DEPARTMENT OF RECREATION, PARKS & CULTURAL ACTIVITIES

Ewald Park Survey Highlights

Report for John Ewald Park Design Feedback

Ewald Park Redesign

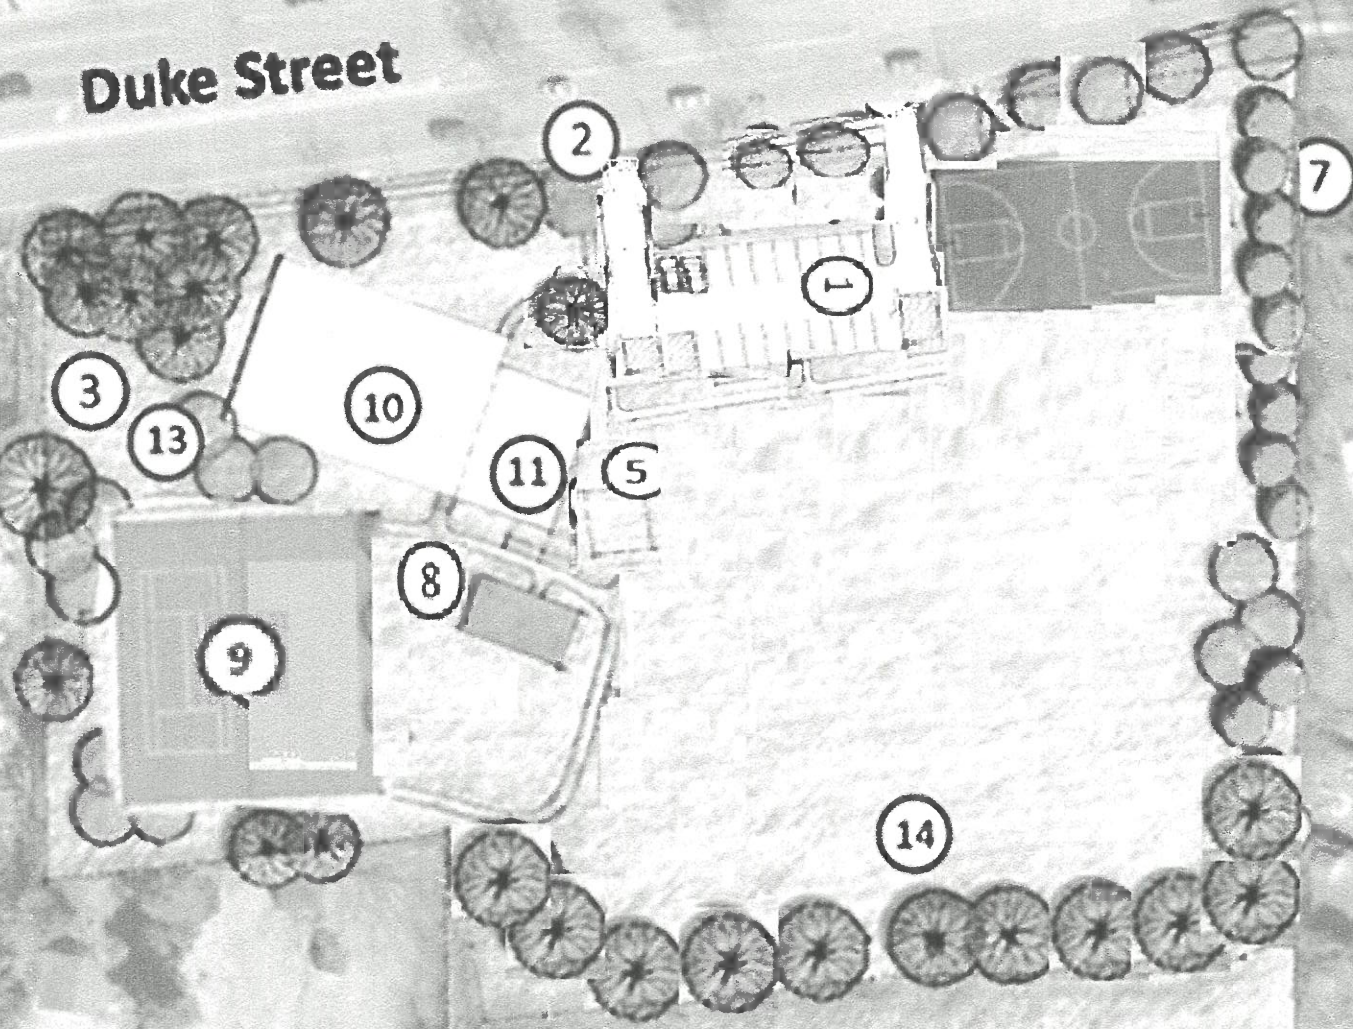
Field Kept Open, As-Is, for all p/u sport / Kept large enough for little league play / Gathering area for **migratory birds!**

Field **Drainage** left Intact. (concrete drainage box behind south fence may not have capacity for increase flow caused by any further development- Esp Irrigation, Hard Pavings, incl Synturf or Trail-walkways)

Lowers possibility of flooding of Underwood or S. Iris properties. Place all perimeter **lighting on Timers**, w/ Solar Power?

Relocation of Lot and B.B.Ct is Paid largely by No further development of Field (exc perimeter trees) B.B.Ct can face N/S in line w/ Tennis Assc recommends and saves space for longer Lot. No community cost/benefit for two B.B.Ct.

Use of Existing Driveway Skirts utilizing Full Bus lane for access to Duke east. (Must have 1.5 traffic lane widths for turning large maint vehicles, emer vehicles and sight distance for exiting park users)

No Ingress/Egress vehicular can be made safe w/o "At Least" one full turn/merge lane w/ adequate acceleration and sight distances.

Design shows **full 56' curved entrance "ramped" on left side** to accomodate 2' elevation rise. Two parking spaces on right side entry near playground for handicap. Right side of entrance can be raised slightly, and existing B.B.Ct can be lowered slightly to accomodate up ramp to lot. Estimates of spaces can be accomodated with room to spare. Addition of 2 spaces overall but can be lessened or increased if desired.

Existing prkg + B.B. Ct Asphalt / Concrete should be Ground/Pulverized, Repurposed for Base / Mix for new paving and Other Foundations mix. Lights largely left in place

Playground utilizing hillside w/ modern engineering, w/possible re-use of some existing equip. Closer to new parking lot Safer for Emergencies, maint vehicles etc.
